# TABLE OF CONTENTS

## Recommendation Material:

# PROJECT DESCRIPTION

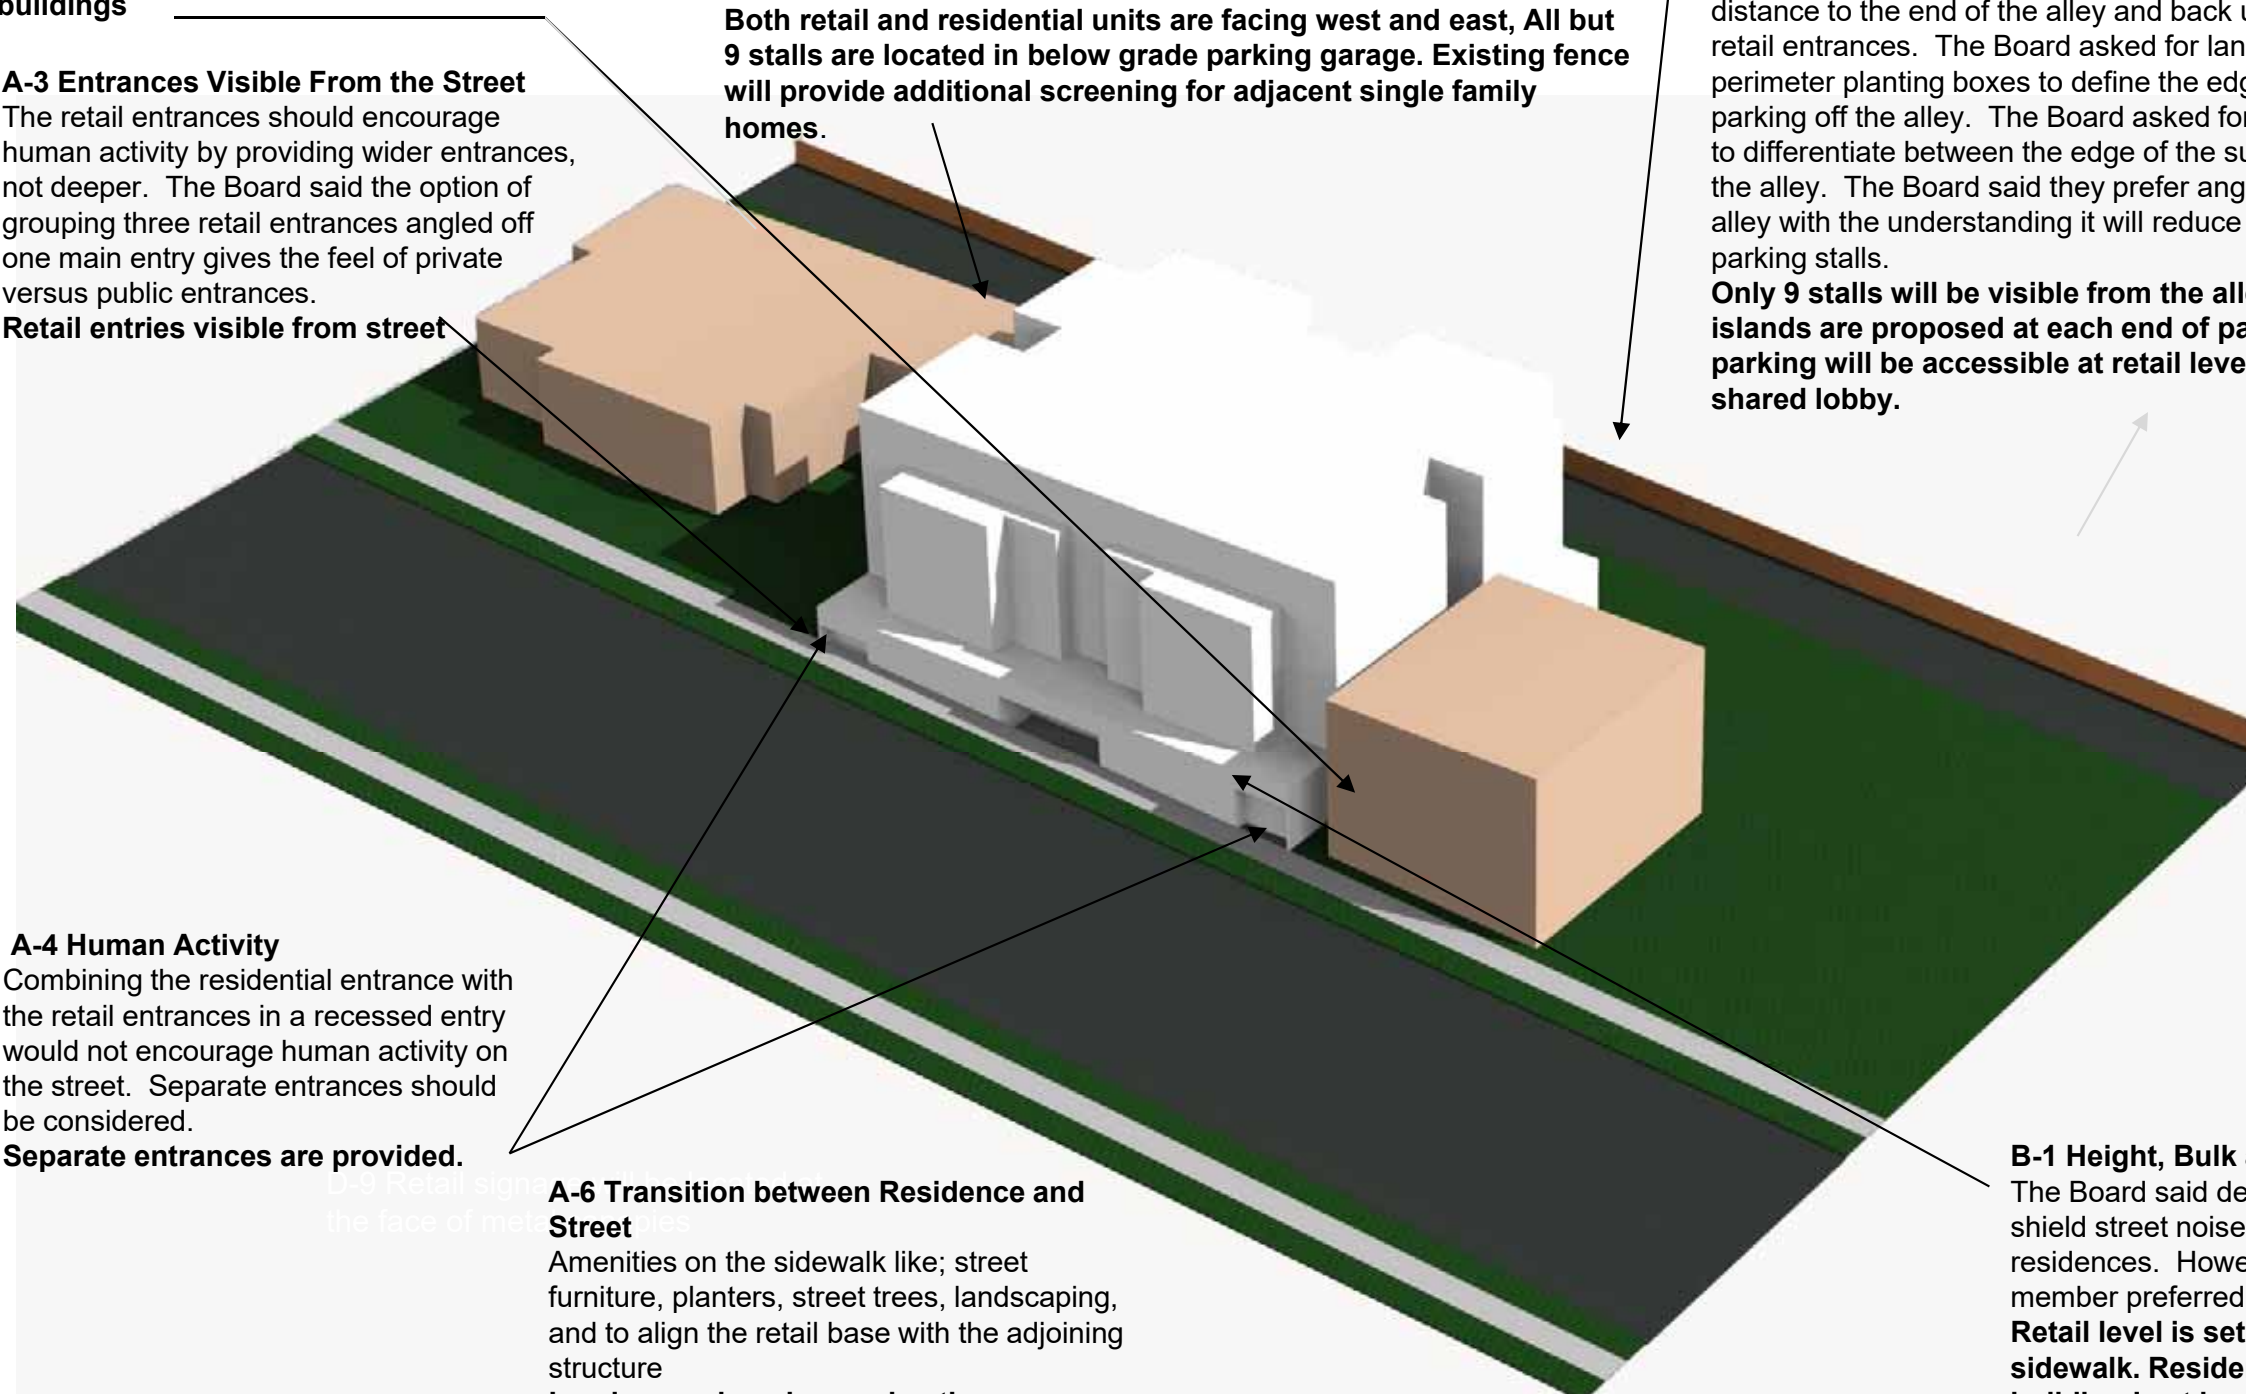
The Board said the surface parking behind the building and along the alley should not intrude on the privacy of the homes and backyards across the alley. The Board said patrons of the retail spaces will not use the surface parking along the alley because it is not visible from the street and the walking distance to the end of the alley and back up the street to the retail entrances. The Board asked for landscaping in perimeter planting boxes to define the edges of the surface parking off the alley. The Board asked for a change in paving to differentiate between the edge of the surface parking and the alley. The Board said they prefer angle parking off the alley with the understanding it will reduce the number of parking stalls.

**Only 9 stalls will be visible from the alley and landscape islands are proposed at each end of parking stalls. The parking will be accessible at retail level by means of shared lobby.**

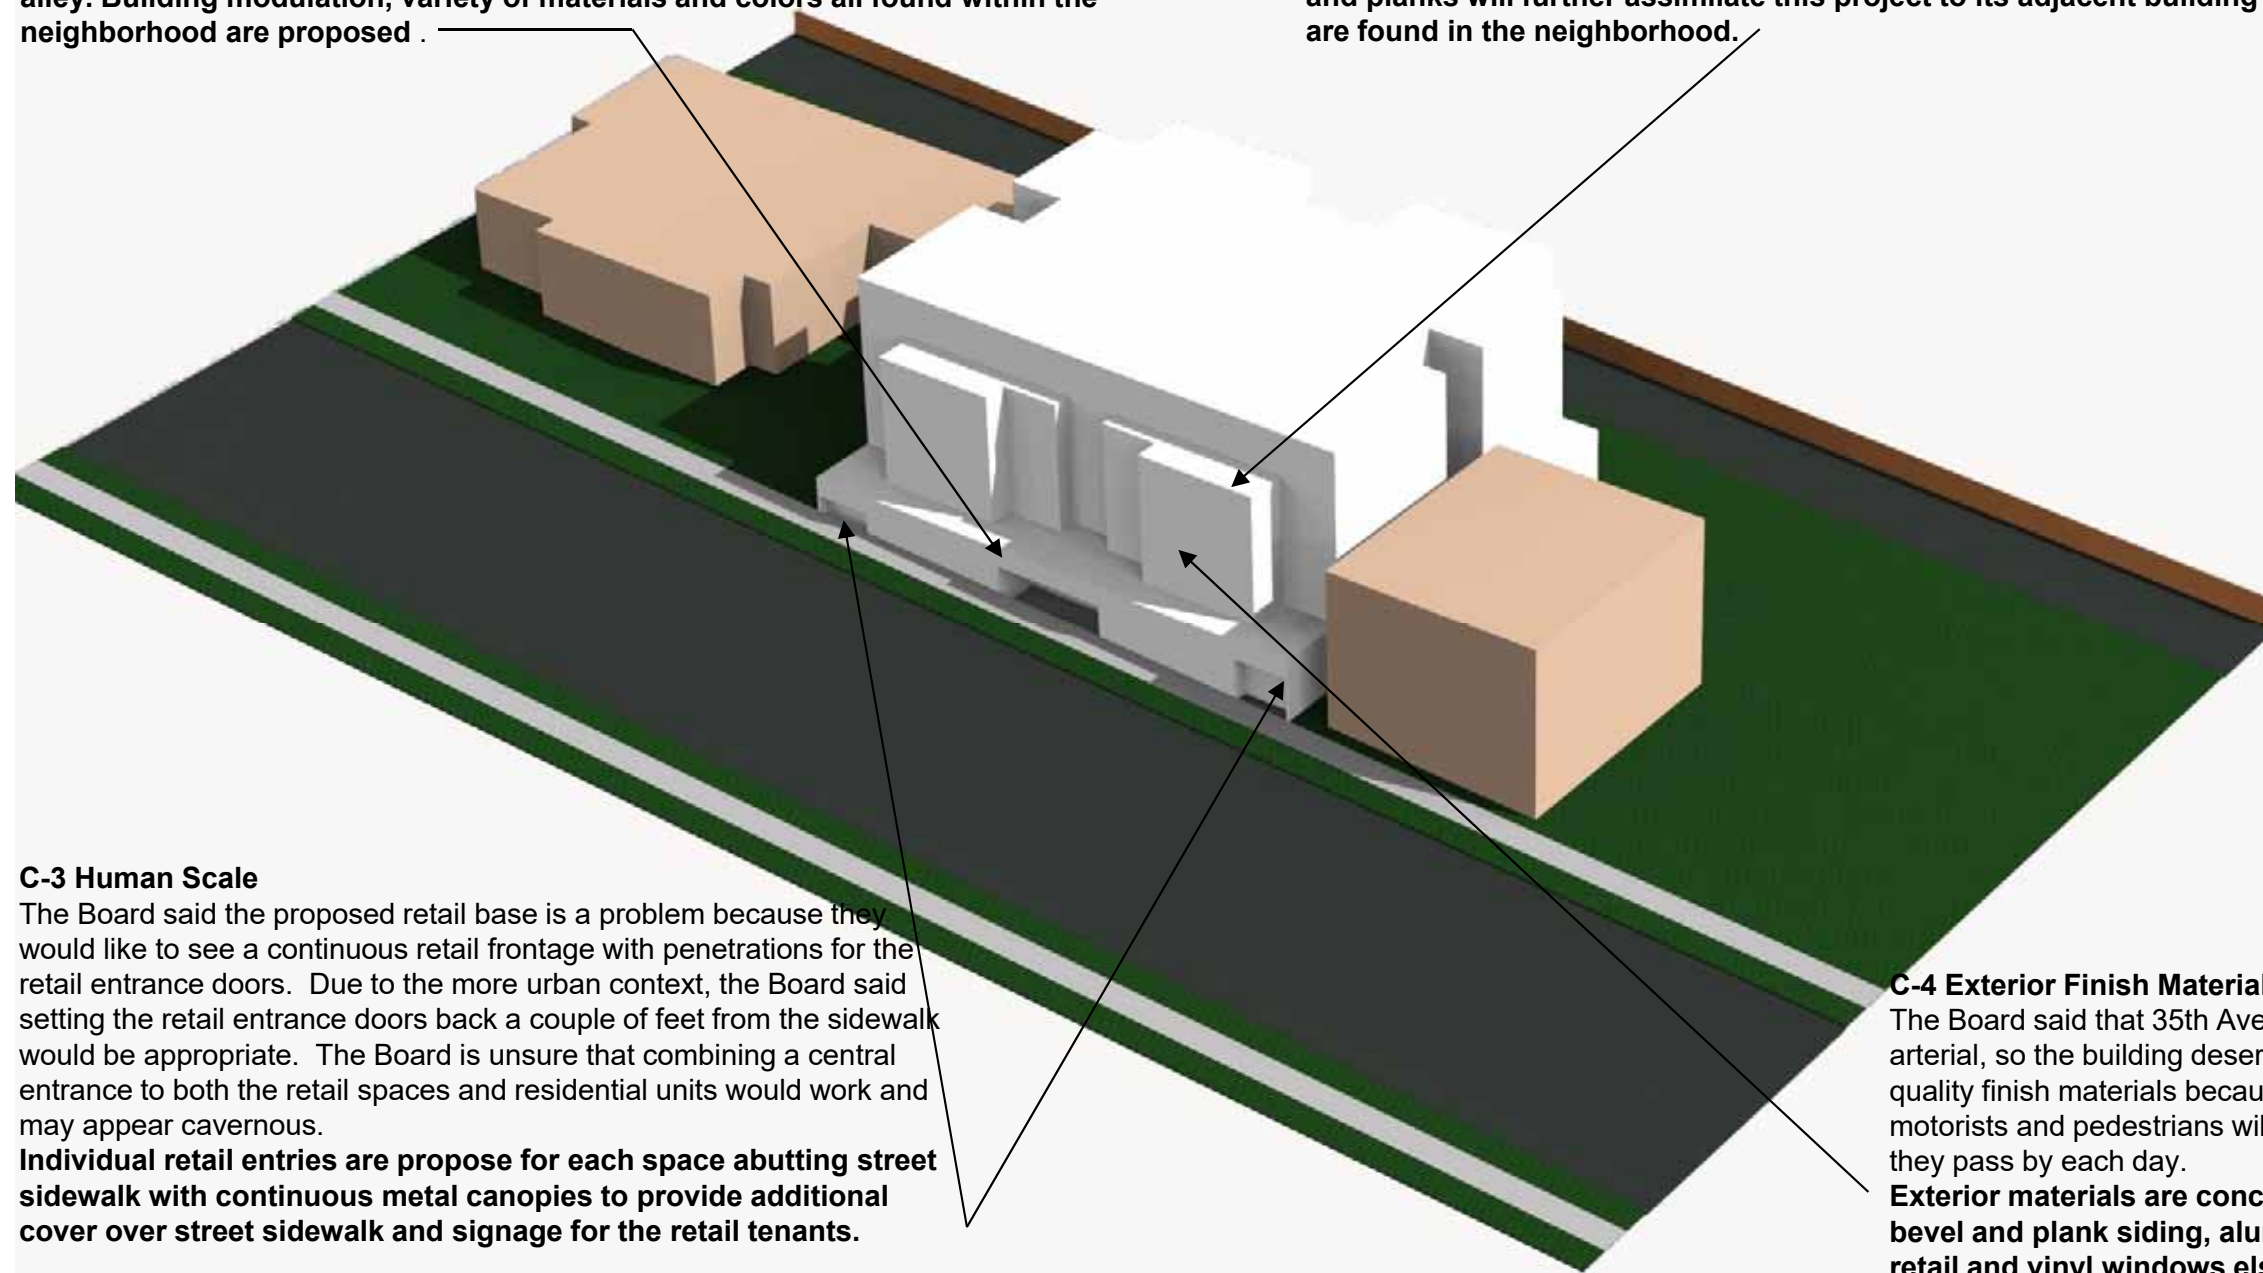
The Board said massing scheme 2 is the correct approach. The Board said this block has a long street front and they envision that the block will be completely built out at some point. The Board said this project has enough street frontage to establish the character for the future build out of this block. The Board said the balconies and modulation should be used to push the building back from the street on the residential tower portion of the structure. The Board suggested a development standard departure if needed to trade bulk along the alley in lieu of stepping the building back from the street on the residential tower. The Board would like to see a rendering of the building at the recommendation meeting to illustrate how the retail base will be playful.

The Board said the proposed modulation and stepping back in the preferred massing proposal appears to be located on the extremities of the structure instead of on the front and back of the building where it will most visible. The Board said the placement of the modulation and stepping of the building could have a large impact on how it feels to be in and around the project. The Board said there should be some give on the interior setbacks and step back the upper levels of the tower structure to reduce the appearance of bulk from the street. The Board is concerned about the appearance from the street of a very vertical façade on the tower. The Board said they would like to see some thought put into the building design and they do not want to see a “cookie cutter” design for a standard mixed-use building.

The Board said the proposed retail base is a problem because they would like to see a continuous retail frontage with penetrations for the retail entrance doors. Due to the more urban context, the Board said setting the retail entrance doors back a couple of feet from the sidewalk would be appropriate. The Board is unsure that combining a central entrance to both the retail spaces and residential units would work and may appear cavernous.

The Board said that 35th Avenue SW is a major arterial, so the building deserves to have good quality finish materials because thousands of motorists and pedestrians will see the building as they pass by each day.

**Concrete, clear glass in aluminum frames and metal canopies are main materials for retail component of this project Residential component is set back both from ROW and alley. Building modulation, variety of materials and colors all found within the neighborhood are proposed .**

**Both horizontal and vertical modulation have been incorporated to reduce apparent scale of the project as well minimize visual impact . Concrete walls, metal canopies, bevel siding and planks will further assimilate this project to its adjacent building since these elements are found in the neighborhood.**

**Individual retail entries are propose for each space abutting street sidewalk with continuous metal canopies to provide additional cover over street sidewalk and signage for the retail tenants.**

**Exterior materials are concrete, metal canopies, bevel and plank siding, aluminum windows at retail and vinyl windows elsewhere**

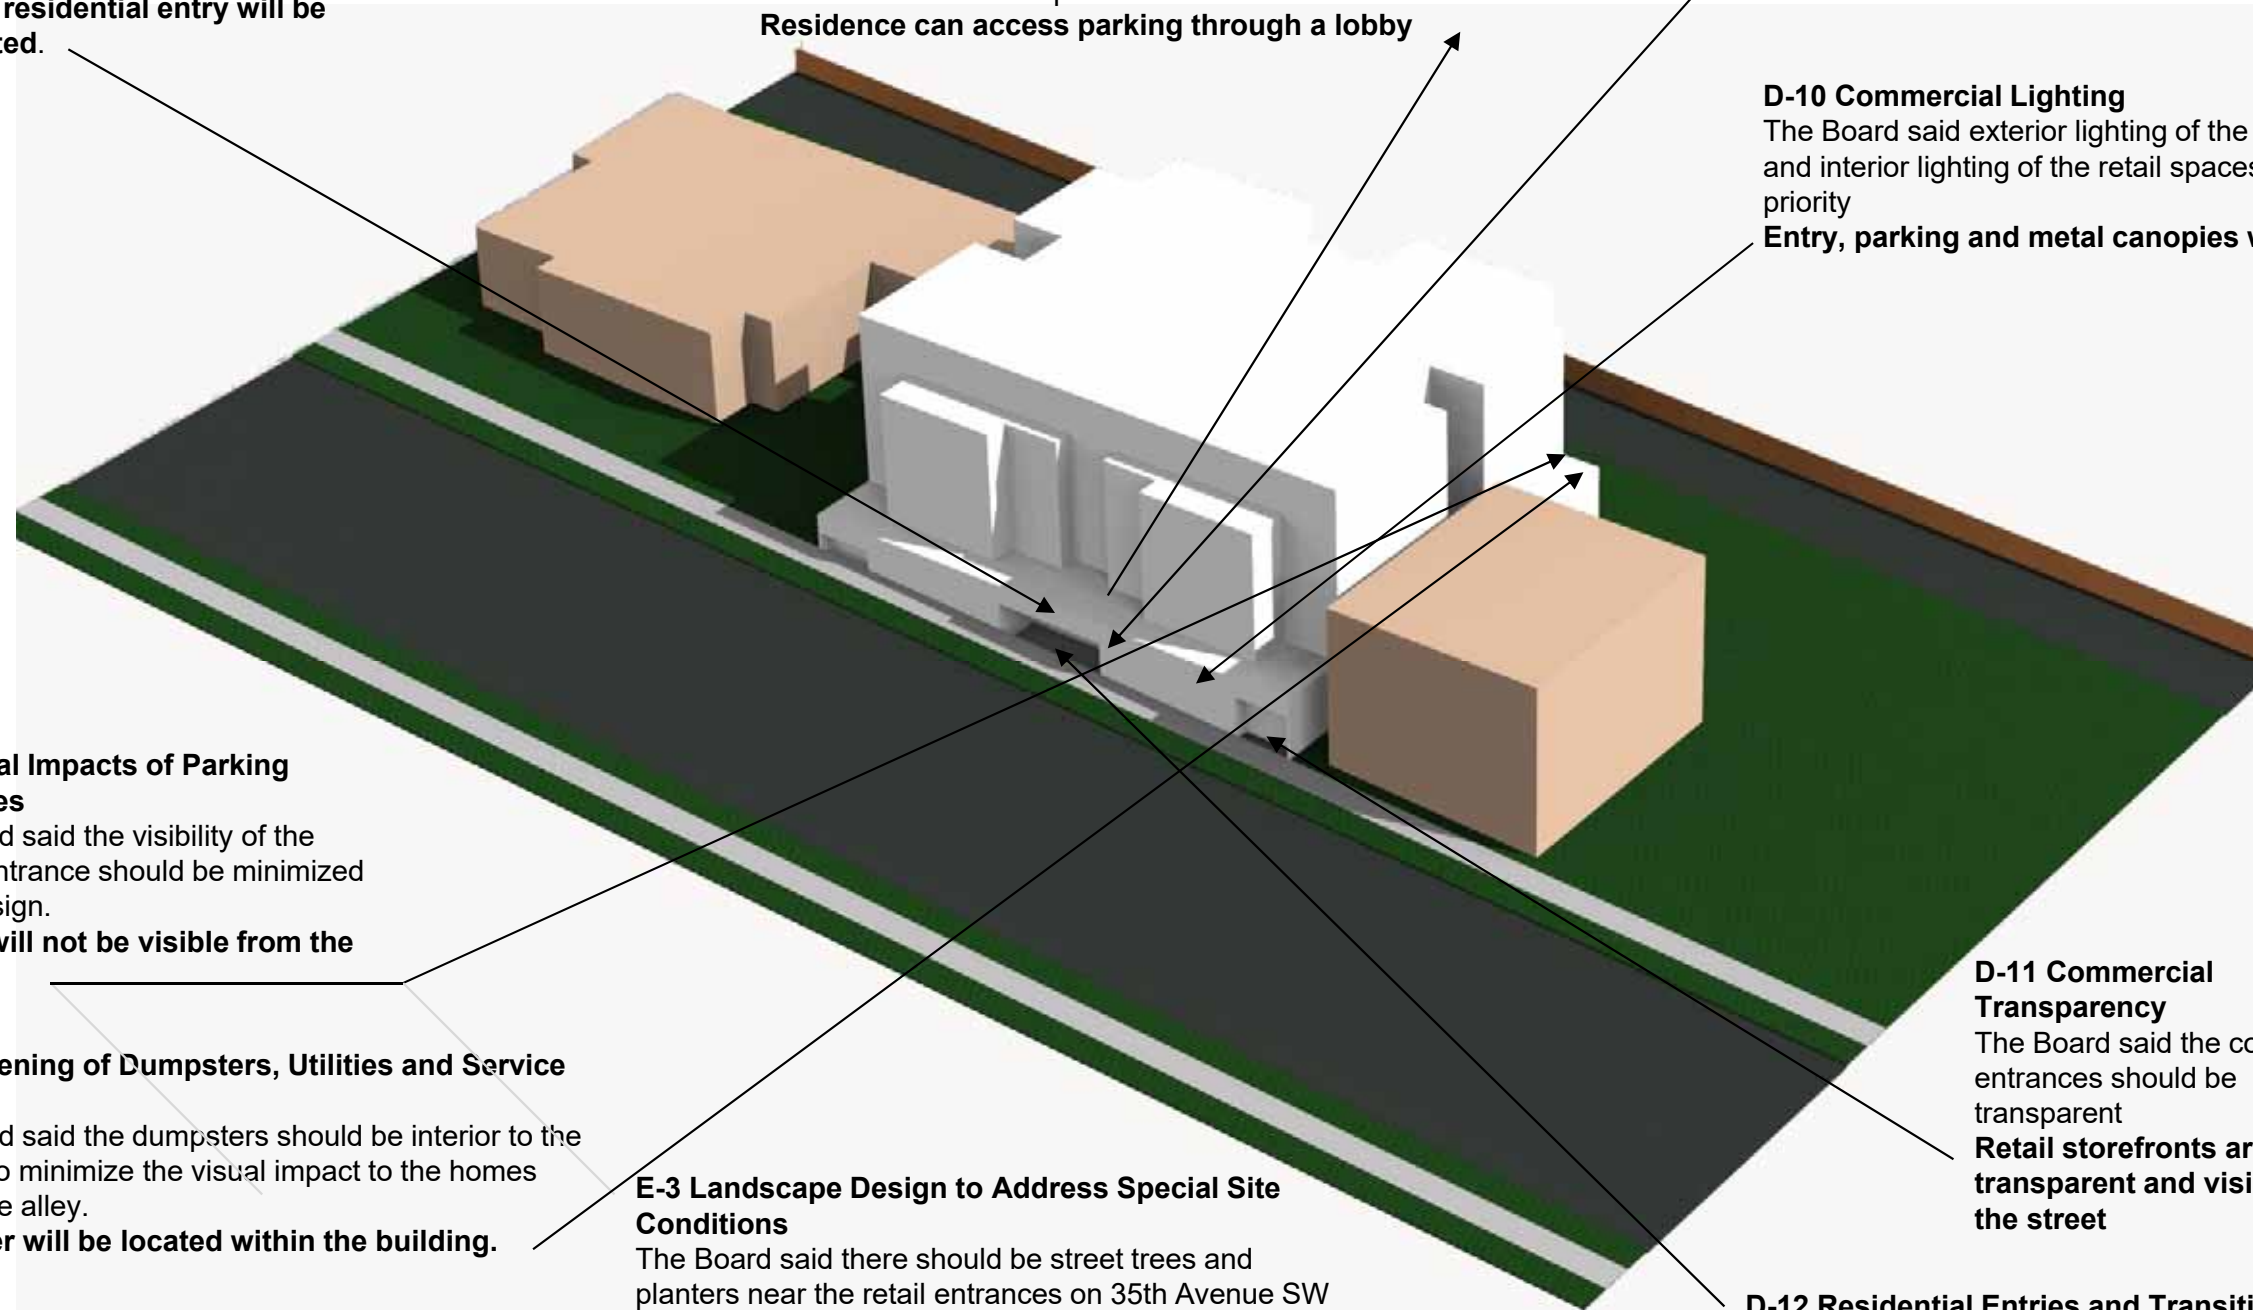
The Board said the commercial entrances should be transparent

The Board said a separate secured residential entry and transition from the sidewalk is a high priority.

**Retail storefronts are transparent and visible from the street**

**Residential entry is covered and prominently located**
